**Department of Planning and Environment**
Issued under the Environmental Planning and Assessment Act 1979
Approved Section 4.55 (1A) Modification Application
No: SSD 10437 MOD 1 Granted on 16 August 2022
Signed: AW Sheet No: 1 of 21

Project
WATERLOO METRO QUARTER DEVELOPMENT

Sheet title
General Arrangement Plan
Ground Floor Plan

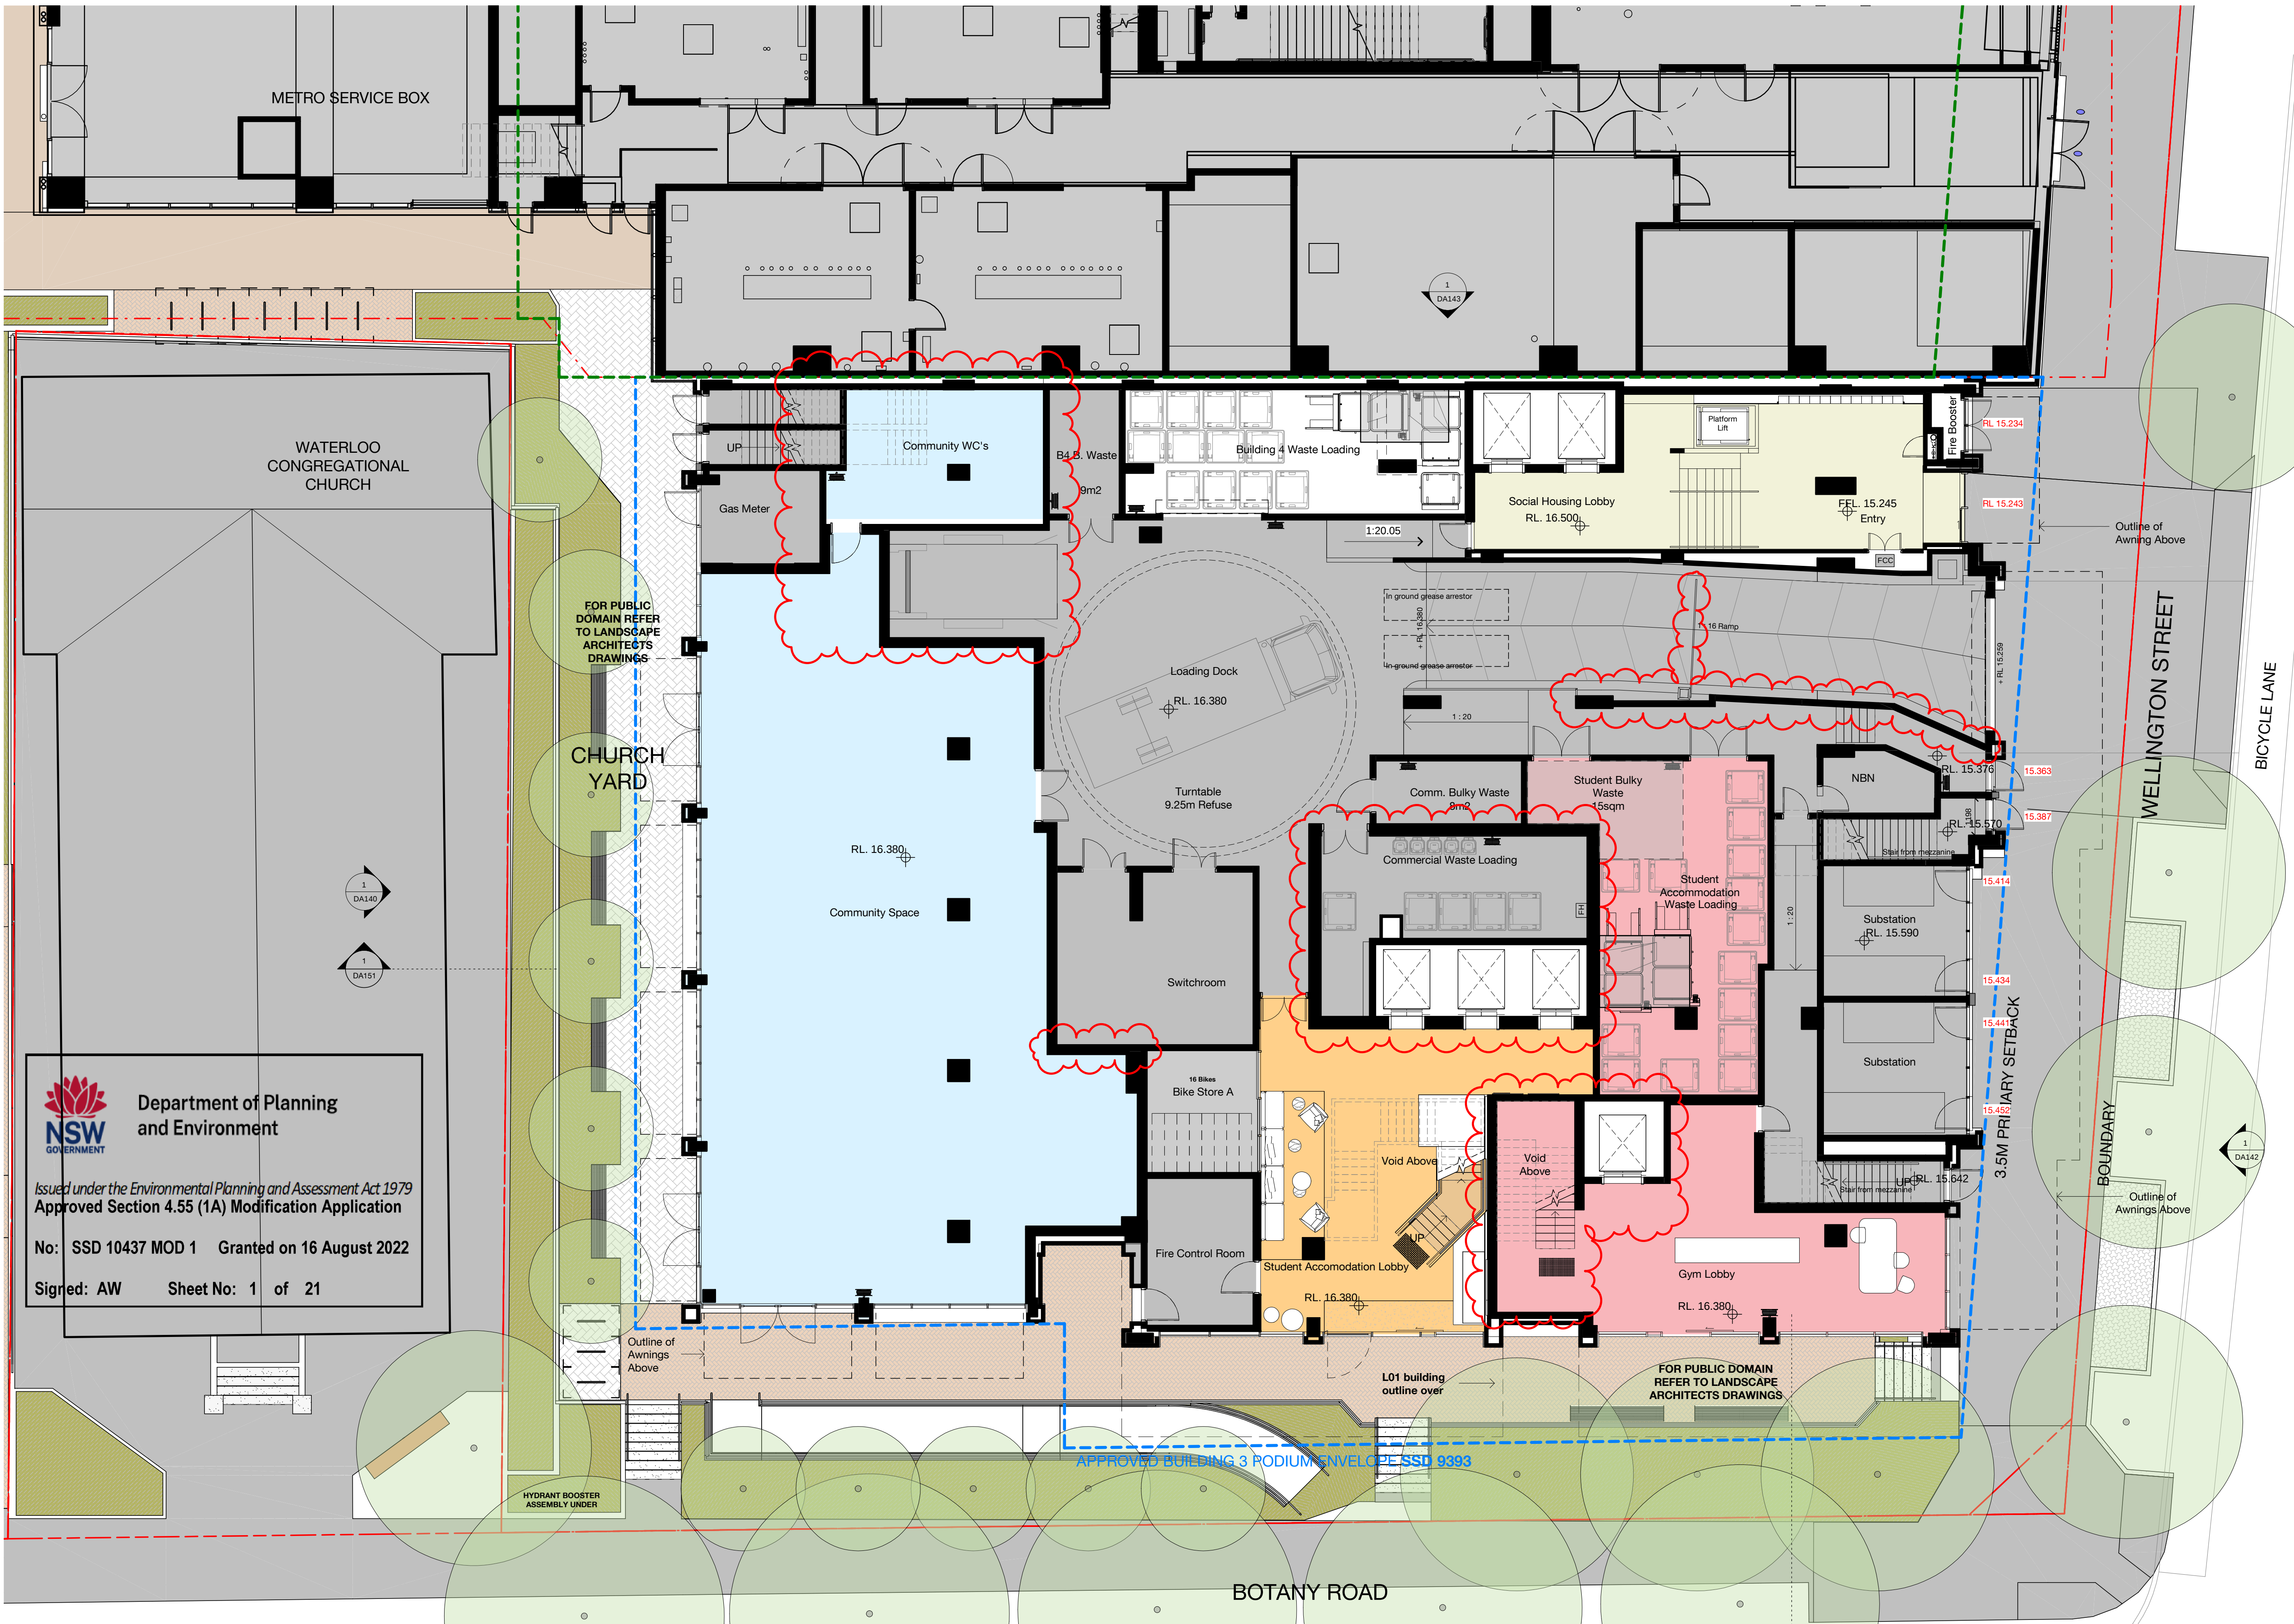
- Modification Changes
- Student Bulk Waste reconfiguration
 - Switch room change
 - Student Accommodation - reconfiguration to the core and services
 - Gym - lift and stair reconfiguration
 - Addition of block wall and boom gate to loading dock driveway
 - B99 Space reconfiguration

General Arrangement Plan
Level 1 Plan

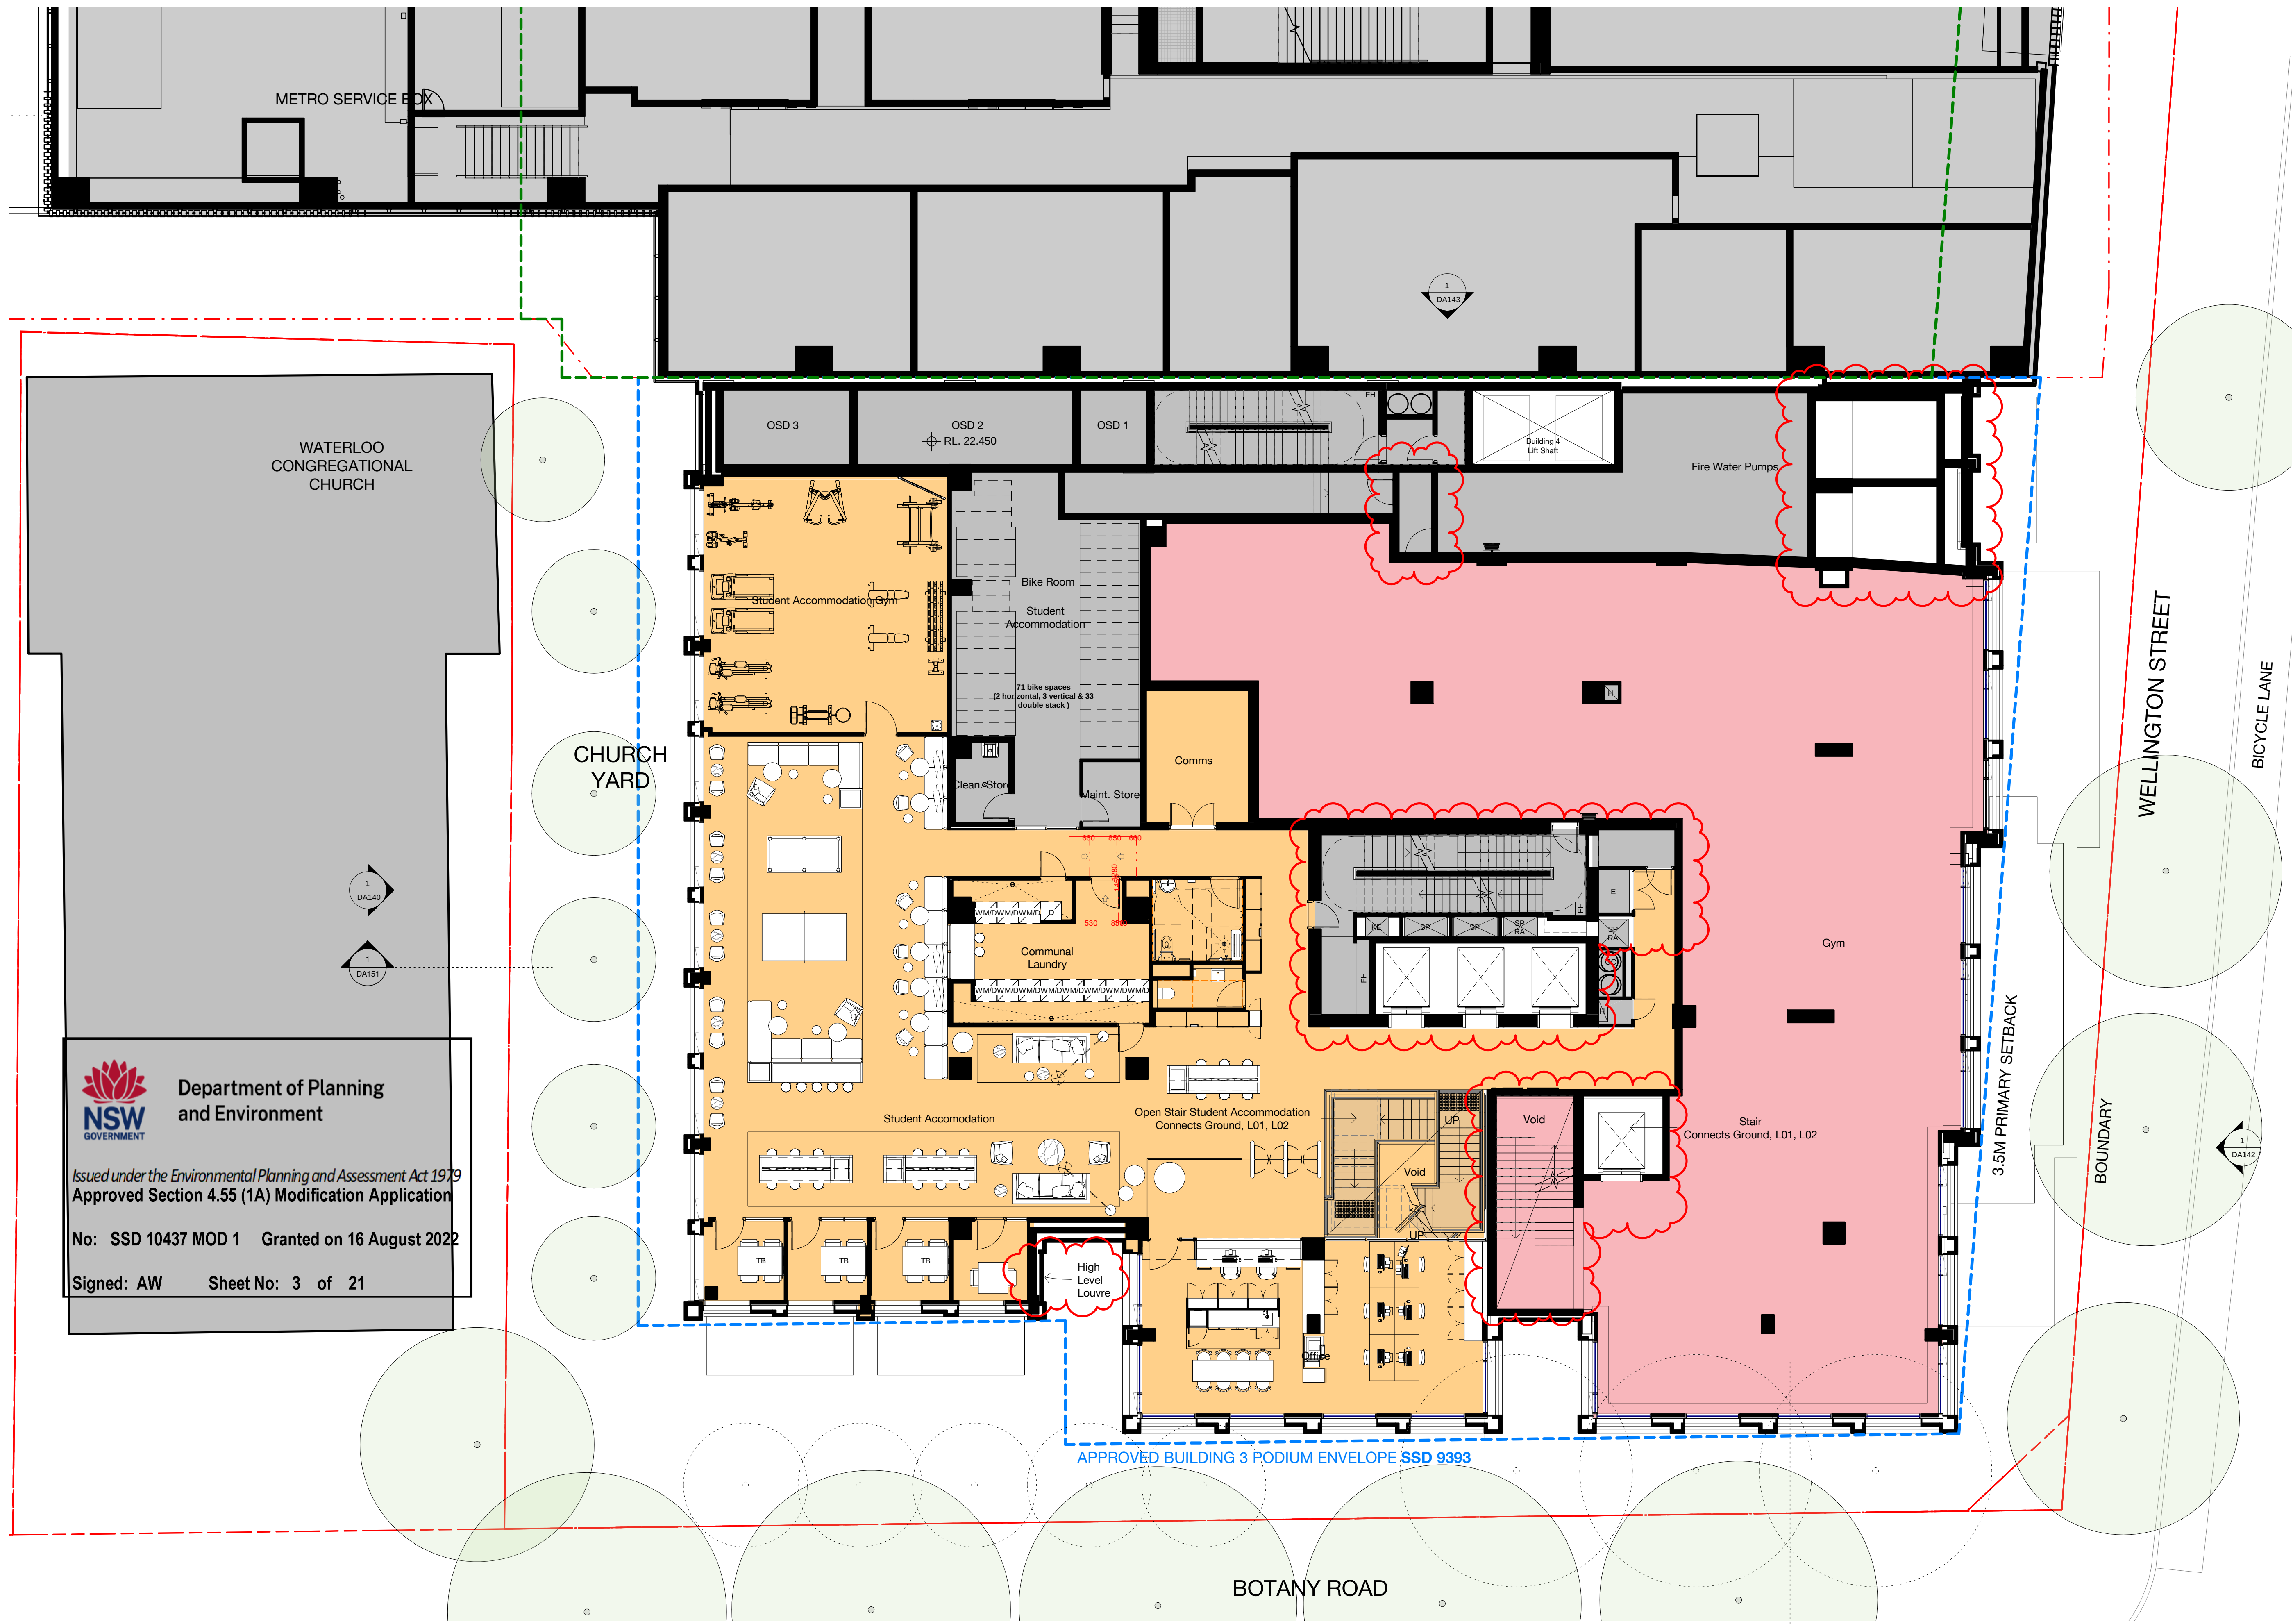
- Student Accommodation - reconfiguration to the core and services
- Gym - lift and stair reconfiguration
- Addition of louvers to podium of the mezzanine level and level 1
- Airlock reconfiguration

Sheet title
General Arrangement Plan
Level 2 Plan

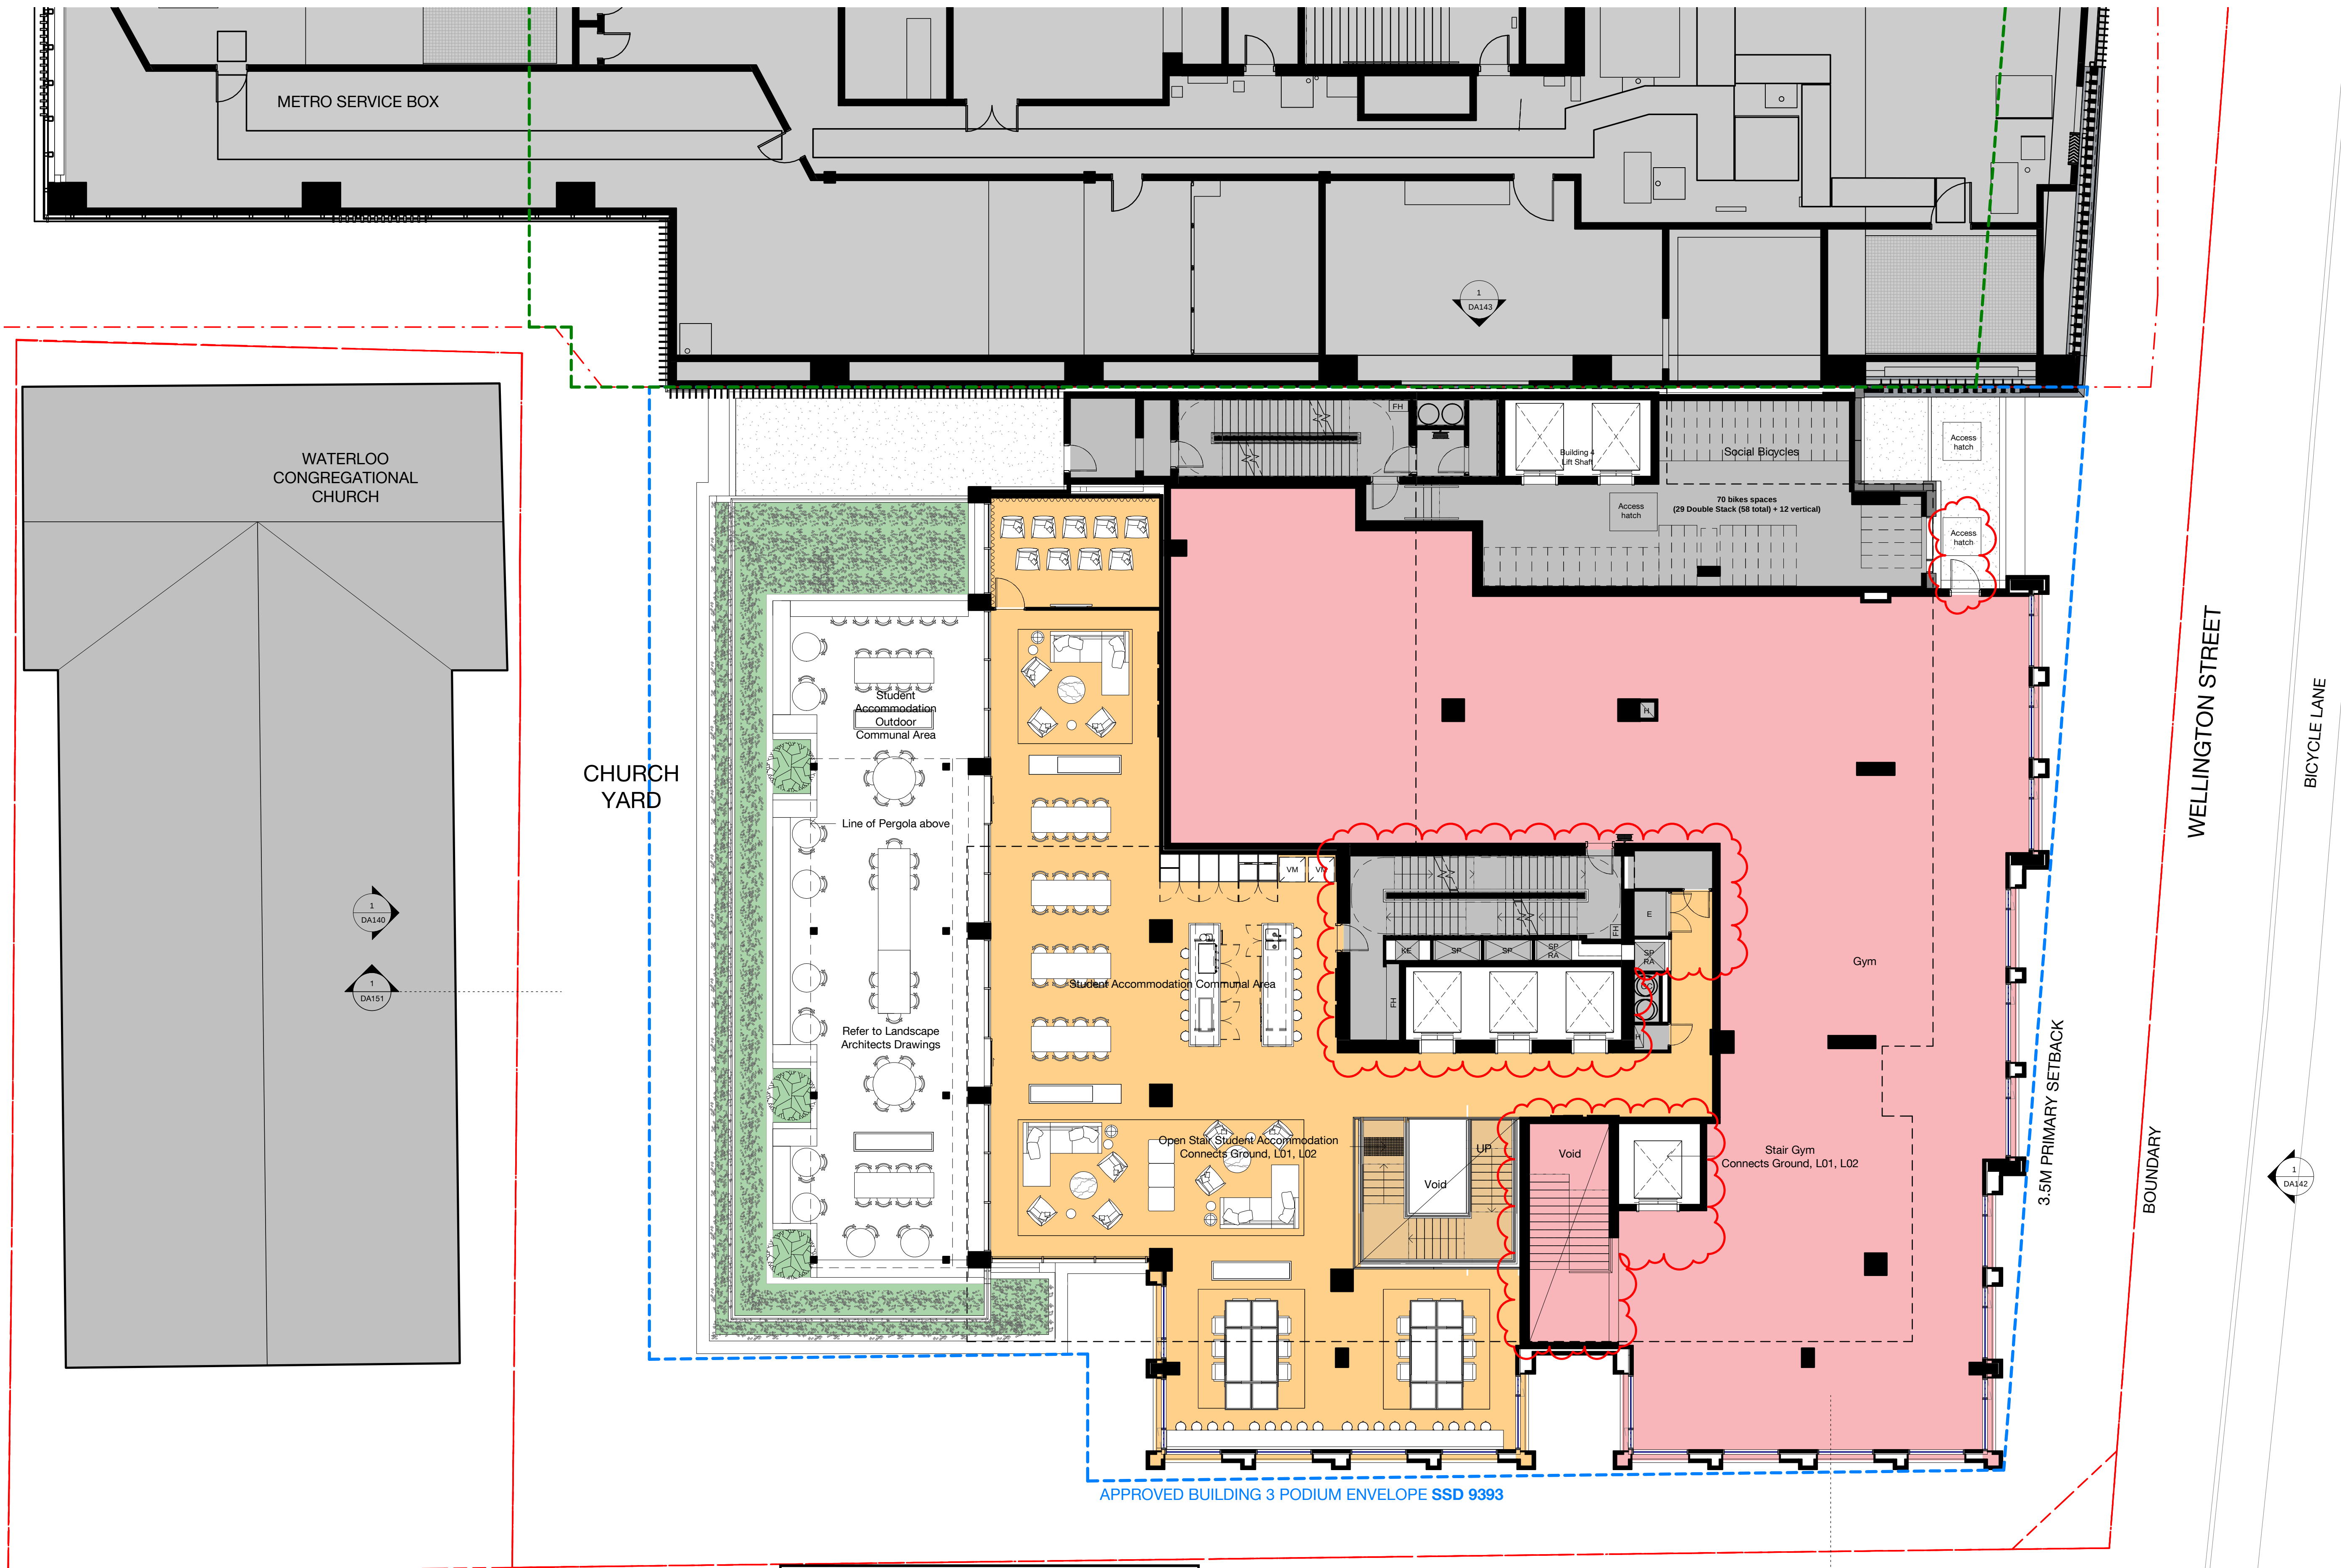
- Modification Changes
- Student Accommodation - reconfiguration to the core and services
 - Gym - lift and stair reconfiguration
 - Addition of access hatch
 - Additional services door to podium roof
